File: A038/19

Minor Variance
Application

Staff Report Prepared By: Adriana MacPherson, Assistant Secretary Treasurer

Date of Hearing:	Thursday, June 27, 2019
Applicant:	Diane and Lorenzo Paravani
Agent:	Great Room Inc.
Property:	64 Brownlee Avenue, Woodbridge
Zoning:	The subject lands are zoned R2, Residential Zone, and subject to the provisions of Exception 9(769) under By-law 1-88 as amended.
OP Designation:	Vaughan Official Plan 2010 ('VOP 2010'): "Low-Rise Residential"
Related Files:	None
Purpose:	Relief from the By-Law is being requested to permit the construction of proposed addition to the rear of the existing dwelling which will include an attached cabana.

Title:
PROPOSED SITE PLAN

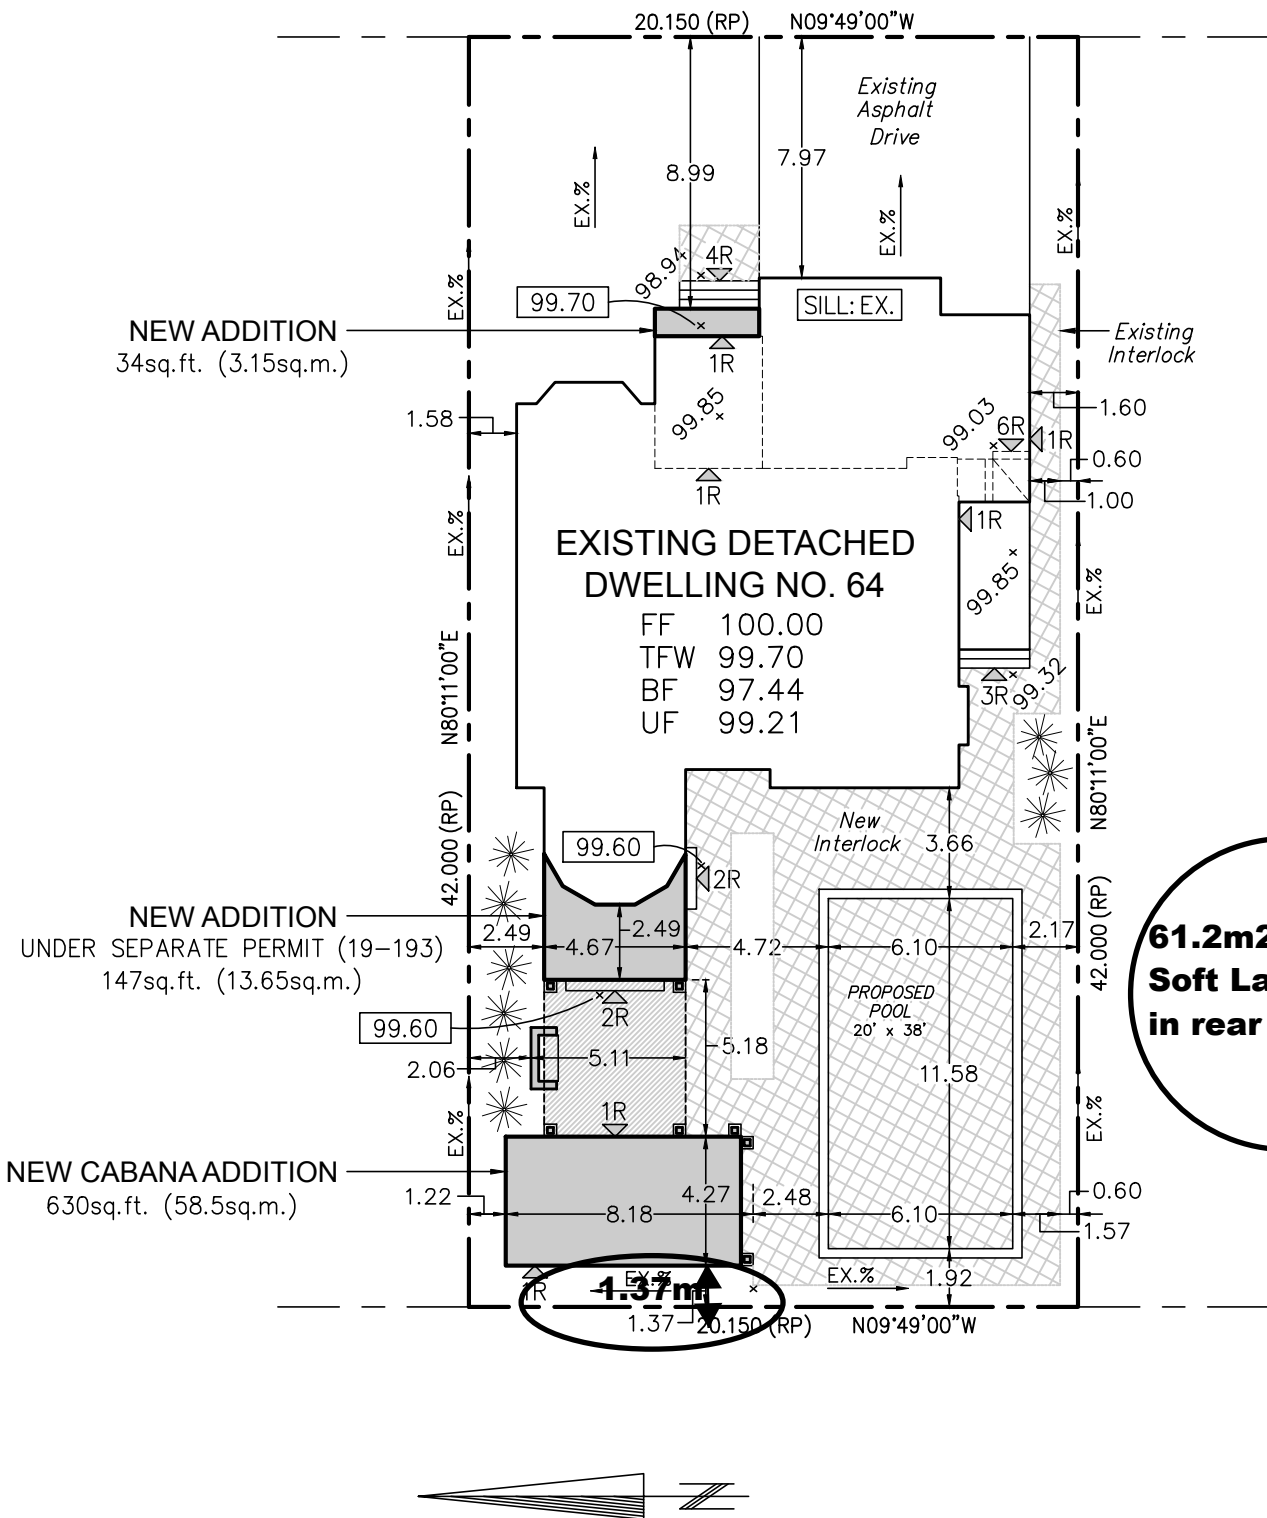
The Owner is requesting permission to construct a pool, covered porch and an attached cabana in the rear yard with the above-noted variances. At the request of the Development Planning Department, the Owner revised their proposal to address massing and height concerns. This resulted in the removal of variances concerning height, lot coverage and interior side yard setbacks.

Variance #1 respecting a reduced rear yard setback is considered minor as the cabana is under the maximum allowable height for an accessory structure and will not adversely impact the neighbouring lots.

The Development Planning Department does not object to Variance #2 for a reduced soft landscaping area in the rear yard. The subject lands are adjacent to an existing mature tree on the adjacent property ('tree #5') which will be impacted by the proposed development. As such, an Arborist Report was submitted by Cinerea Urban Forestry Services., dated May 27, 2019, which identified remedial options for tree #5 (for exposed roots) and tree protection measures to be provided on site. The Urban Design and Cultural Heritage Division of the Development Planning Department has reviewed the submitted Arborist Report and concurs with its recommendations.

1. The Owner/applicant shall apply and obtain lot grading approval via grading permit through the Development Inspection and Lot Grading Division of the City's Development Engineering Department for the proposed addition and cabana prior to any work being undertaken on the property. Please visit or contact Development Engineering's front desk on the 2nd floor of City Hall to apply.
2. The Owner/applicant shall demonstrate appropriate LID (Low-impact Development) measures to the satisfaction of DE to address the requested decrease in soft landscaping in the rear yard from a minimum of 117.9m² to a minimum of 61.2m².
